RE: GM - Saginaw Site (# 915152)
City of Buffalo, Erie County

Evaluation of the Former GM – Saginaw Facility Investigations

**Project B4295
December 22, 1997**

SHALLOW GROUNDWATER FLOW
Niagara Mohawk Power Corporation
Former GM-Saginaw Buffalo Facility

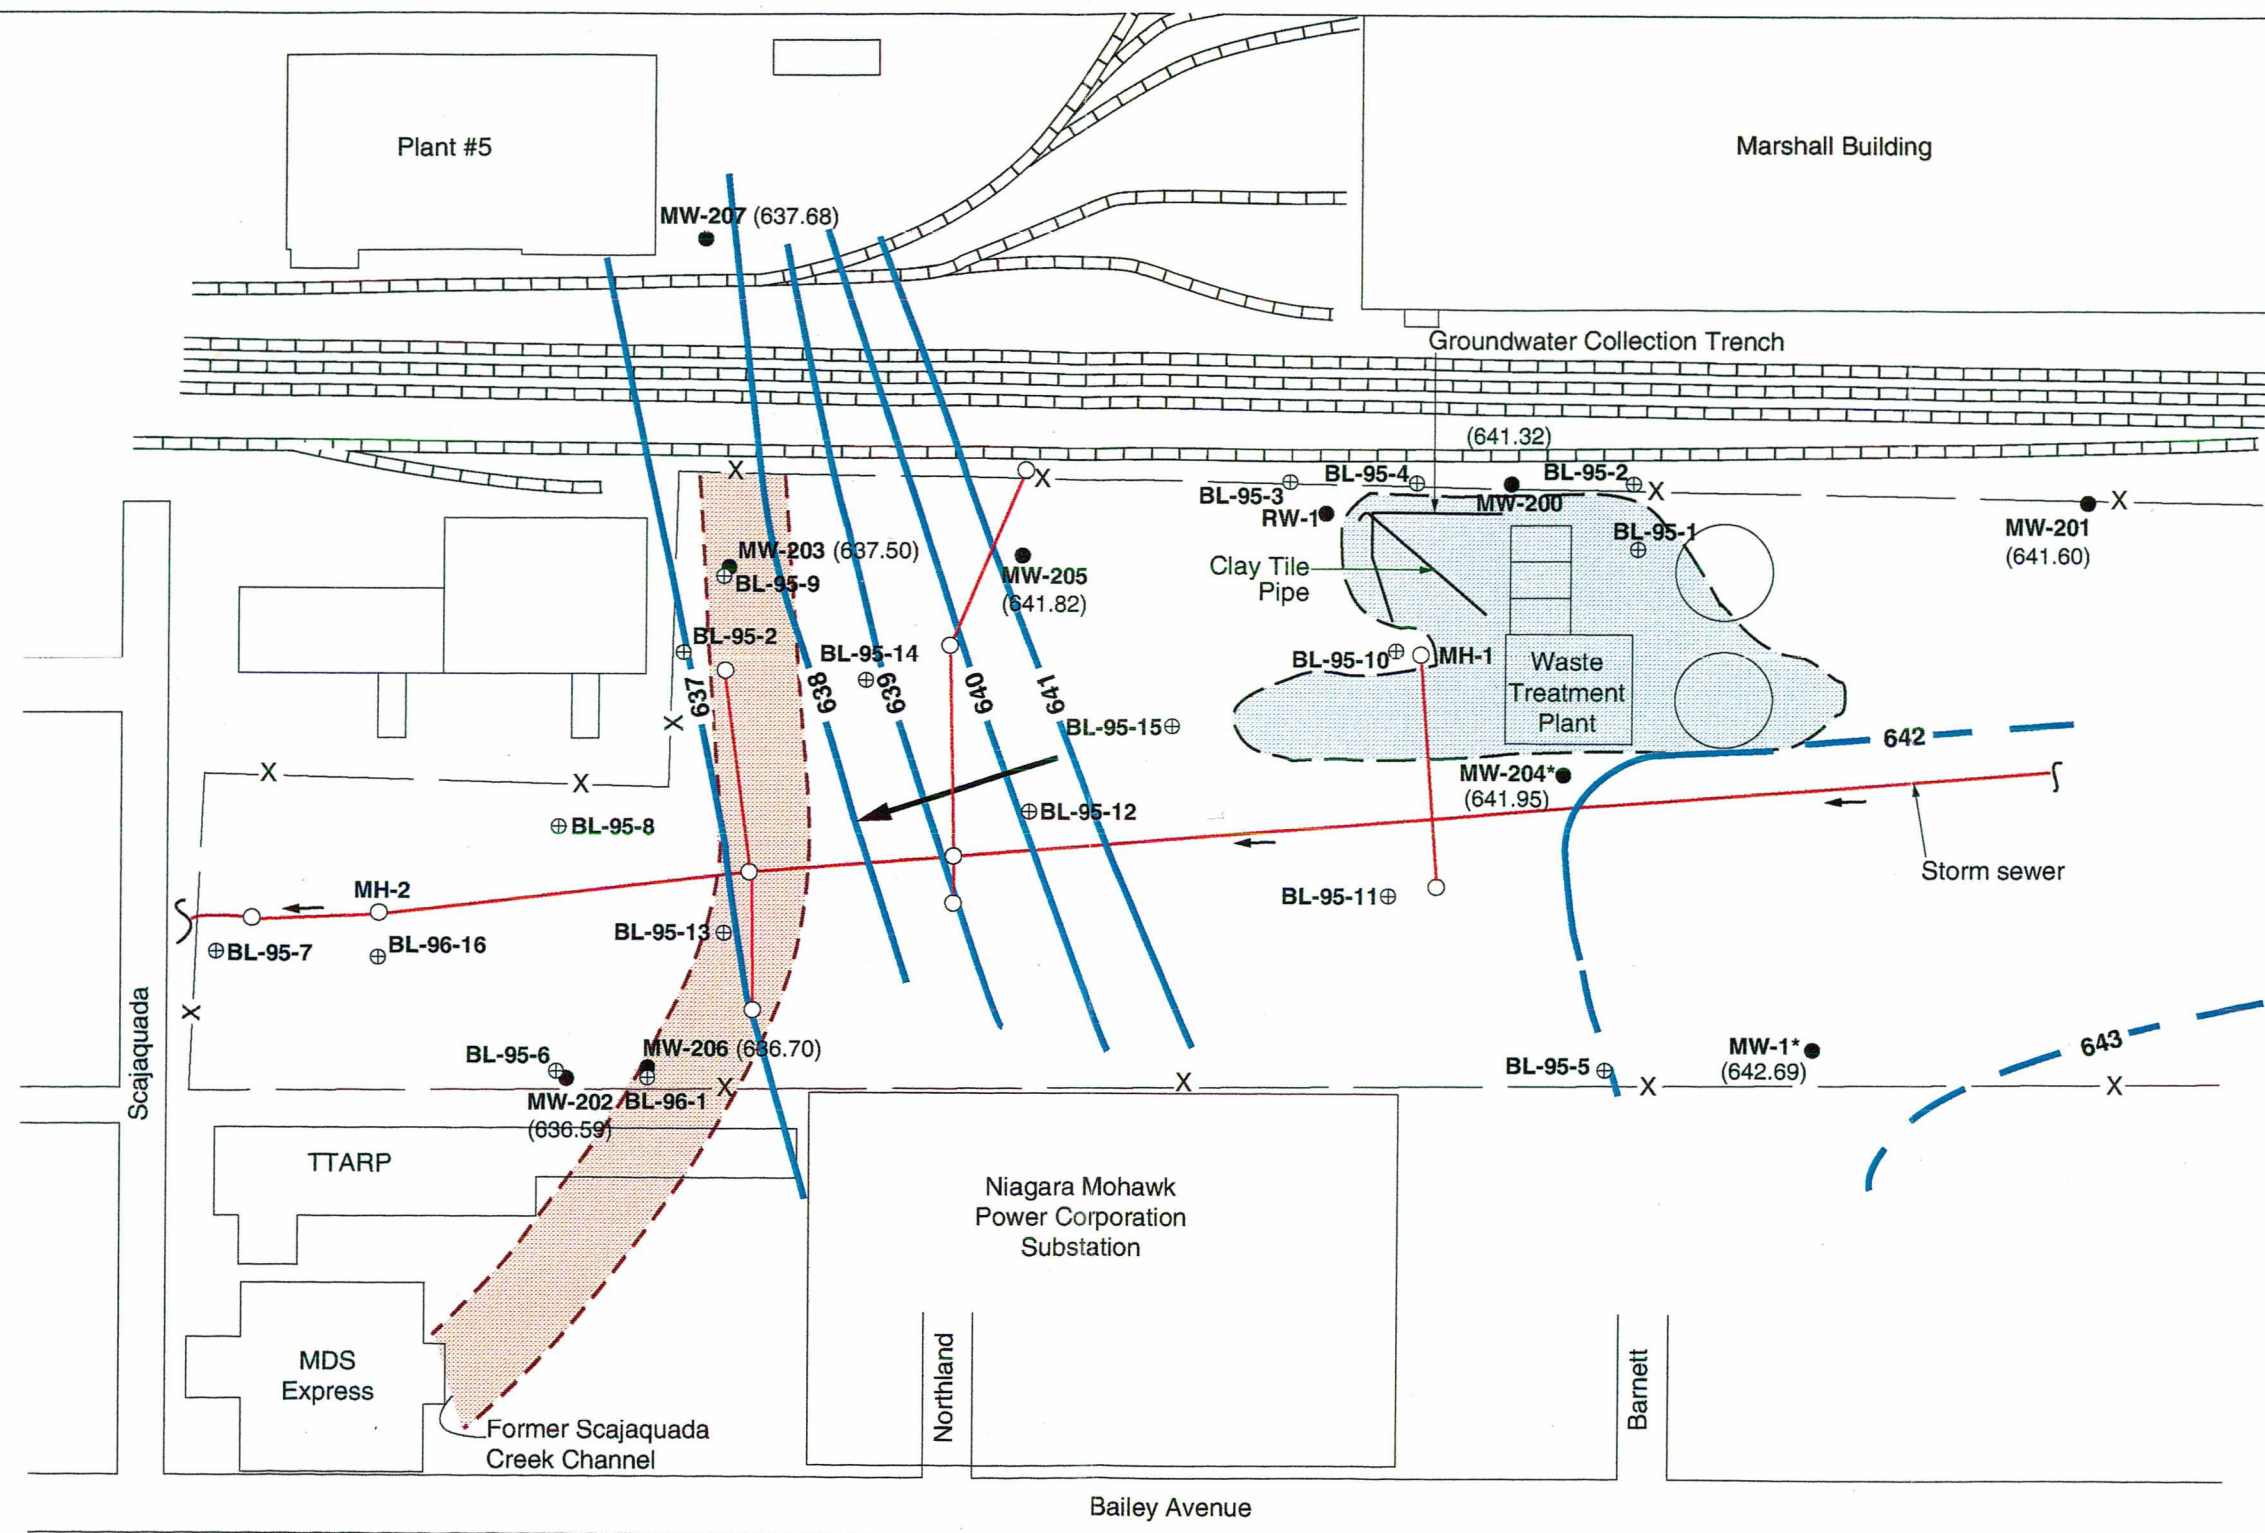
According to groundwater elevations measured in wells installed in the former channel (MW-203, MW-206, and MW-207), groundwater elevations are higher in the west and lower in the east (see Figure 7). As a result, a shallow hydraulic gradient exists in an easterly direction (from the west [upgradient direction] to the east [downgradient direction]). This gradient

allows groundwater and any associated contamination to migrate through the preferential pathway via the in-filled channel towards the NMPC property. This finding is contrary to the erroneous direction of flow stated in the SI Report. Since the permeable fill of the channel can act as a preferential pathway for the migration of contamination, contaminant transport along the sewer lateral bedding materials can occur which enhances migration of contamination to the east.

DISTRIBUTION OF OIL Niagara Mohawk Power Corporation Former GM-Saginaw Buffalo Facility

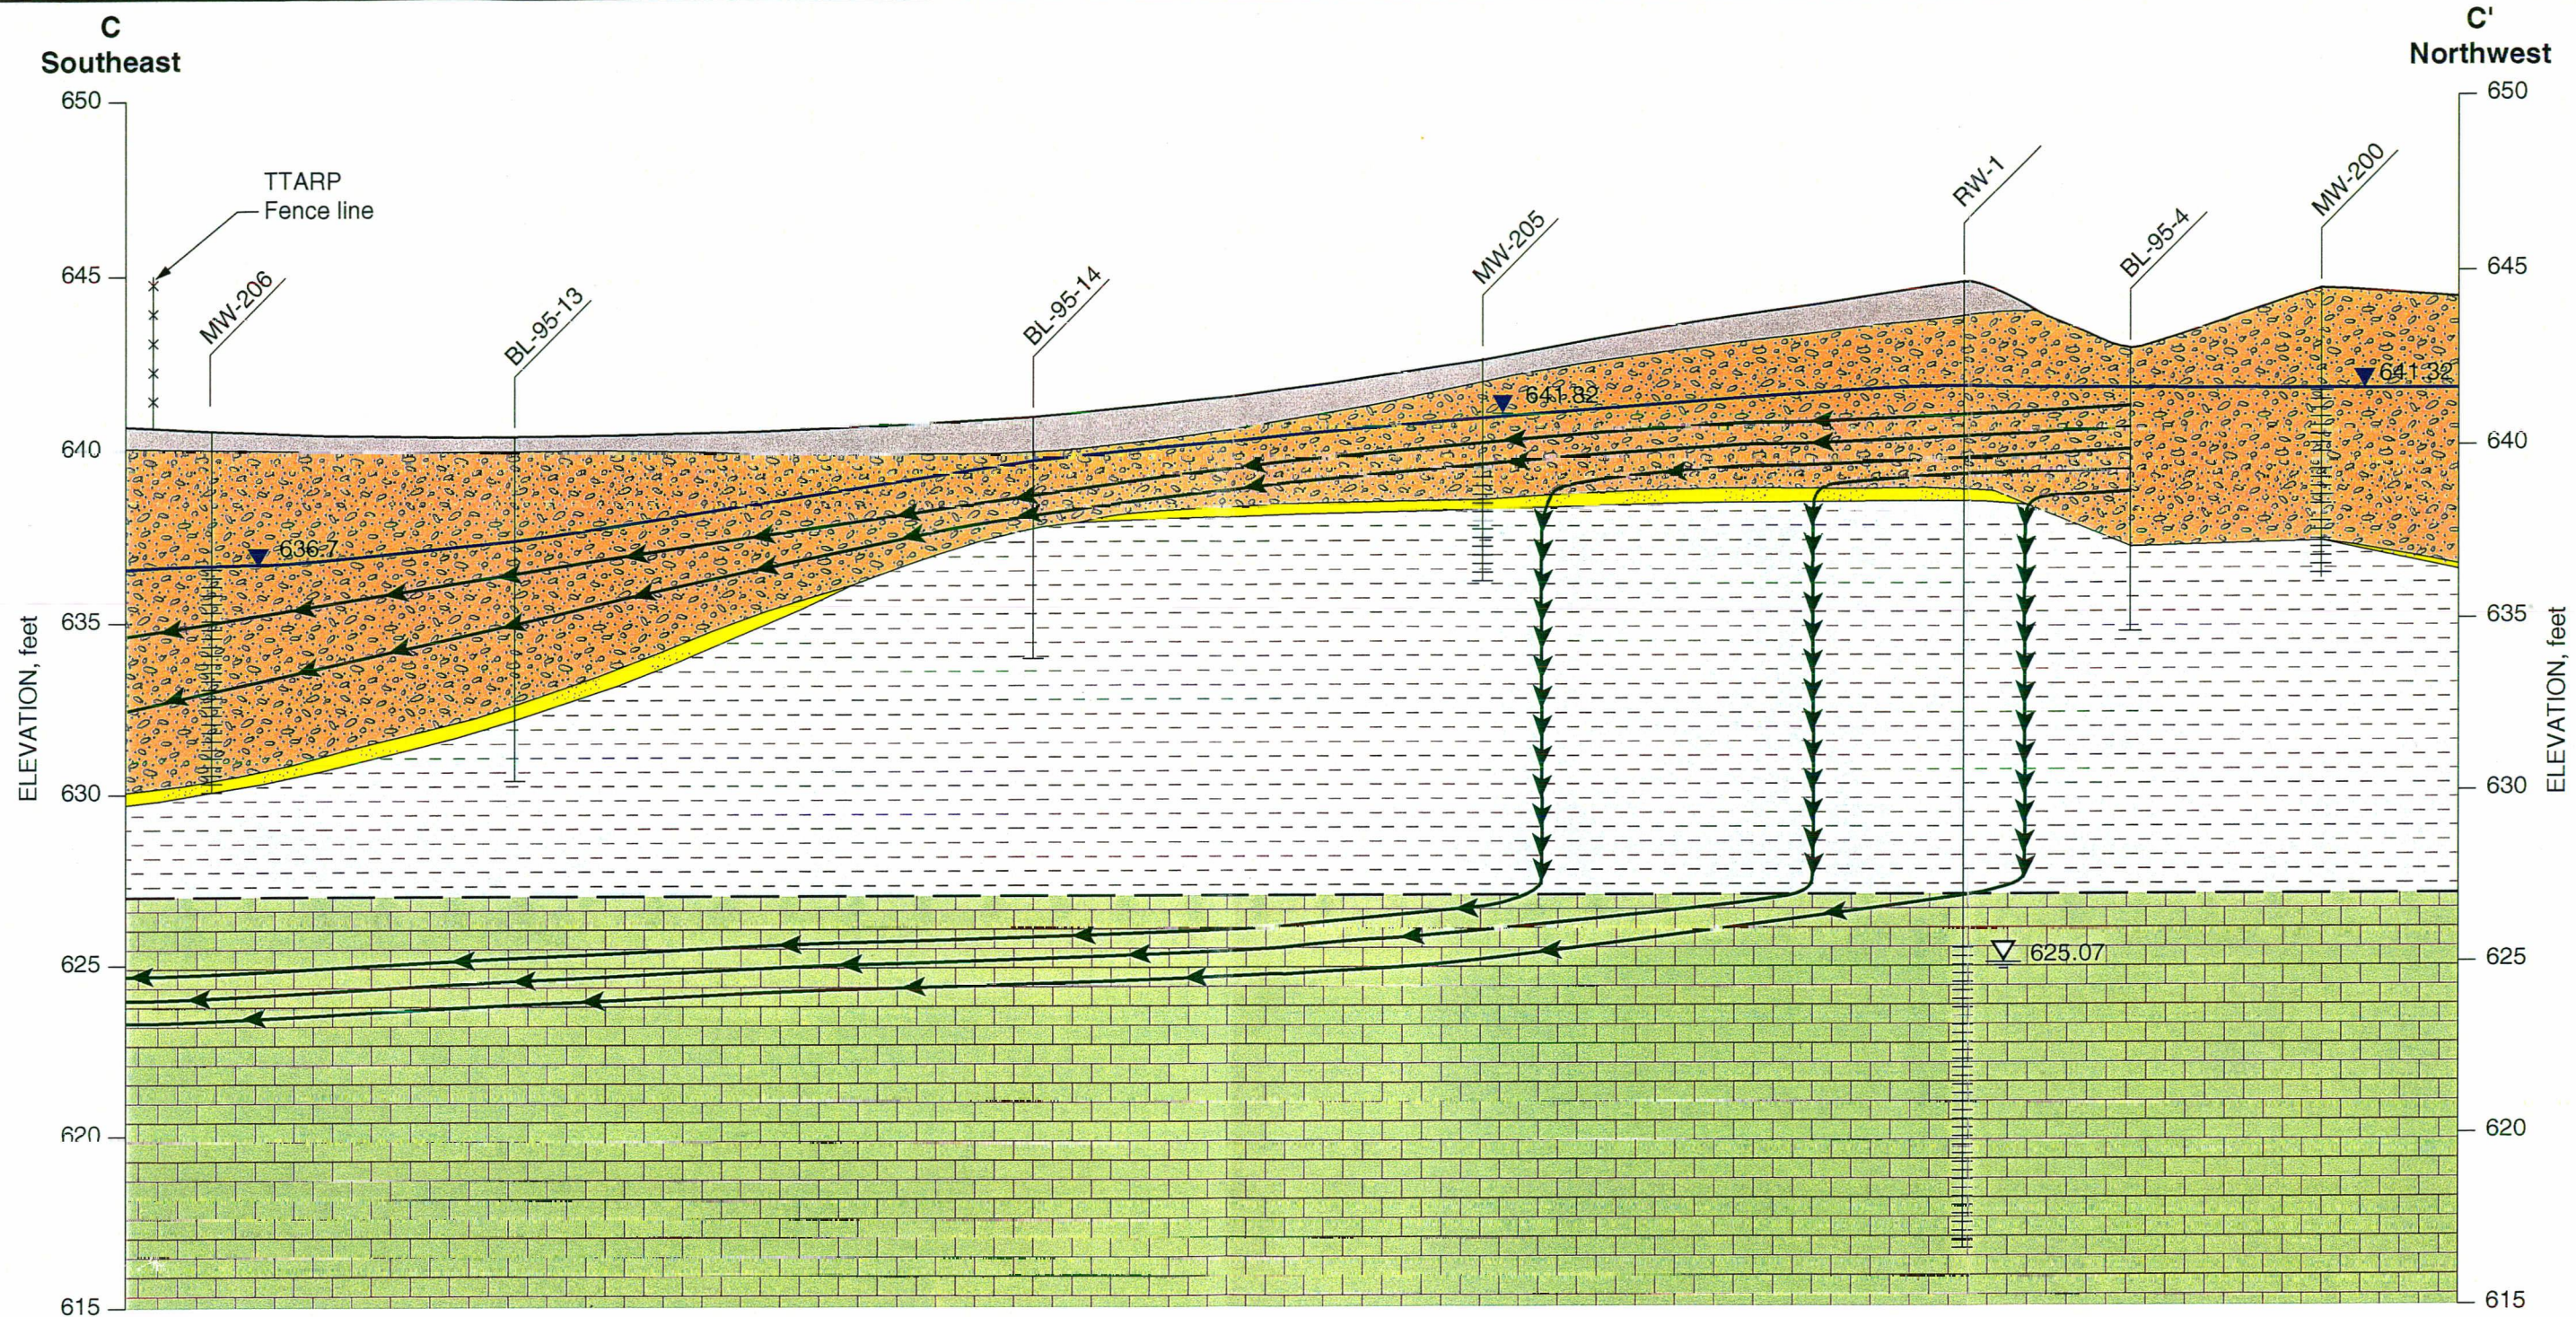
The distribution of oil-stained soil samples collected from soil borings in the vicinity of the source area is shown in Figures 6 and 7. The extent of oil shown on the figures was established by Geomatrix from a review of borehole logs indicating the presence of oil-laden soil or sheens present in split spoon soil samples. Analytical test results of these oily soils indicate that PCBs are constituents present in the free-phase oil and can potentially migrate with the movement of oil and groundwater. Laboratory analysis identified Aroclor 1242, 1248, and 1260 in soil and groundwater samples collected from the source area. As shown in the figures, oily soils were not present in the vicinity of MH-1. This was confirmed by excavation and repair of a portion of the sewer lateral in 1995 which extended 5 to 10 feet to the east of MH-1. However, borings located east of MH-1 in the vicinity of the sewer lateral (i.e., BL-12) identified the presence of oily soils. Oily soils in this area indicate a strong potential for sewer bedding contamination east of MH-1; beyond the area of sewer lateral repair. Investigation of sewer bedding beyond the sewer lateral repair was not documented in the Site Investigation Report or reports provided to the NYSDEC for NMPC review. Sewer bedding materials often act as migratory pathways for contamination from source areas.

No data exist in reports presented to NMPC (as part of this review) that describes any detailed investigation of the sewer bedding along the storm sewer. The only documented investigation of the sewer bedding materials was presented in Section 2.0 of the SI Report that described limited soil excavation to repair a short length of sewer lateral (5 to 10 feet in length) located in the immediate vicinity of manhole MH-1 (see Figure 6).

GROUNDWATER FLOW MODELED
 ALONG CROSS SECTION C-C'
 Niagara Mohawk Power Corporation
 Former GM-Saginaw Buffalo Facility
 Cross Section Evaluation

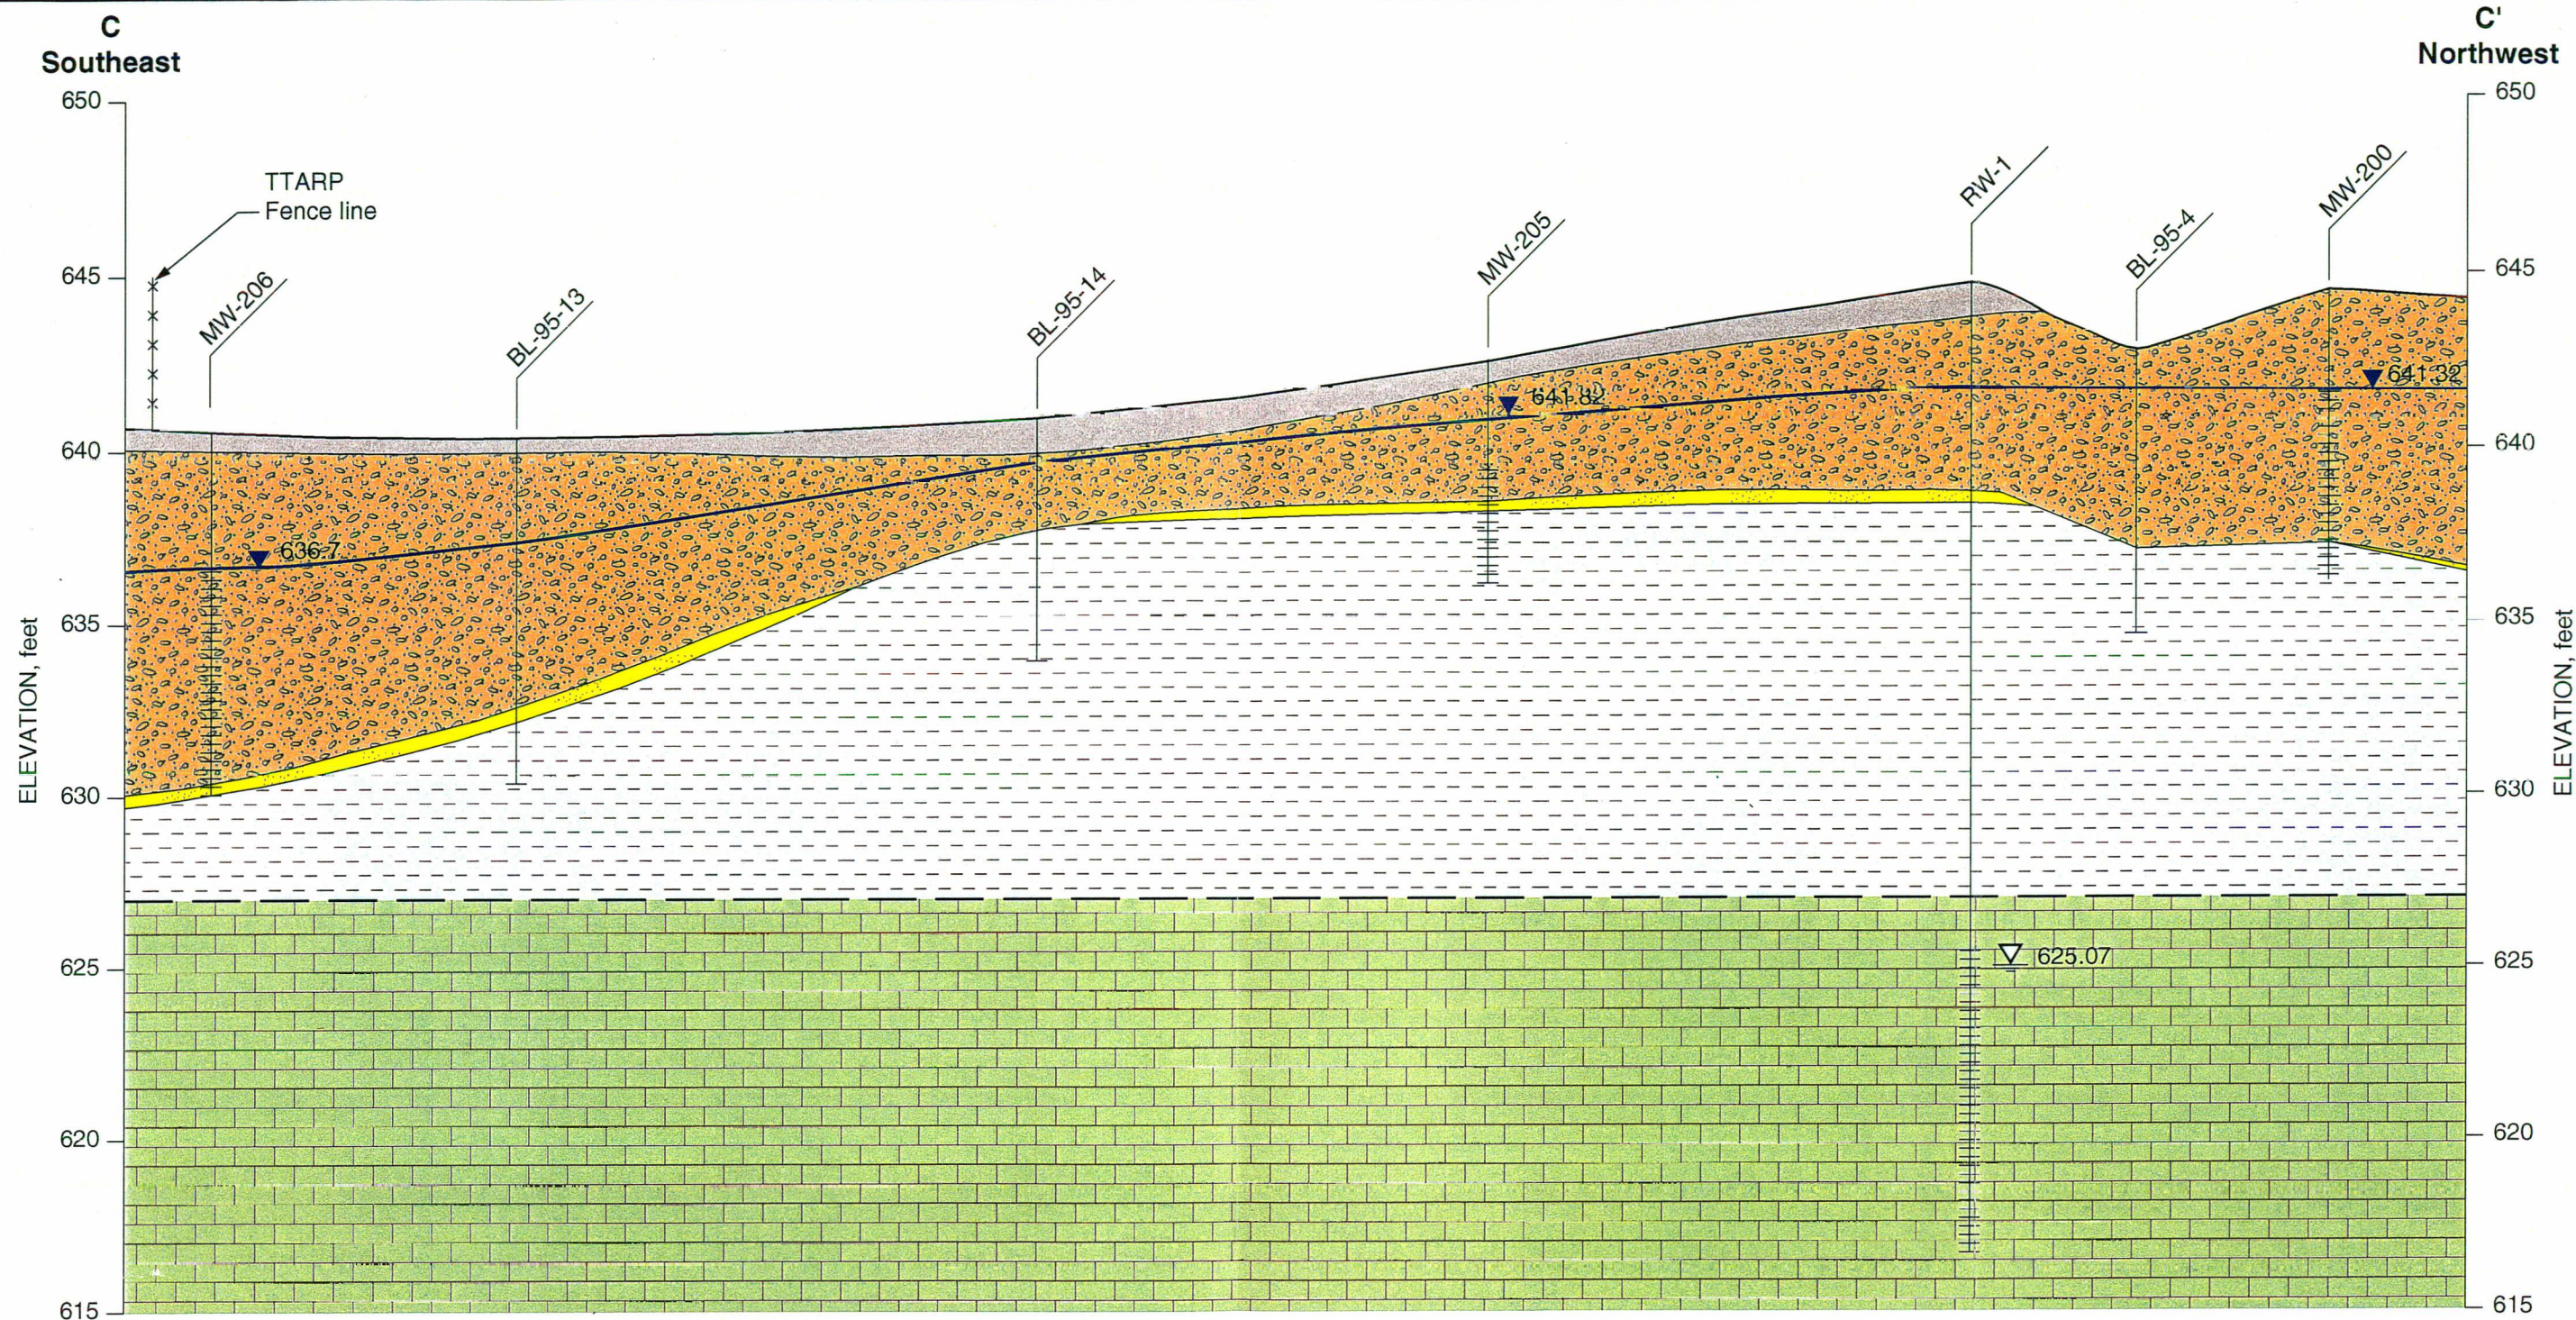
Cross-sectional groundwater flow modeling is presented in Figure 5 along section line C-C' (from the source area to the southeast in the direction of NMPC property). The cross-sectional flow model presents groundwater flow directions and time of travel estimates in saturated soil and bedrock. As shown in Figure 5, groundwater flow velocities (approximately 50 to 60 ft/yr) are moderate through the fill in the direction of the Niagara Mohawk Property. Groundwater from the PCB source area could have reached the vicinity of the Niagara Mohawk property in less than 10 years. Spillage of PCBs occurred during the early 1970's (EMCON Site Investigation Report, 1997), more than 25 years ago.
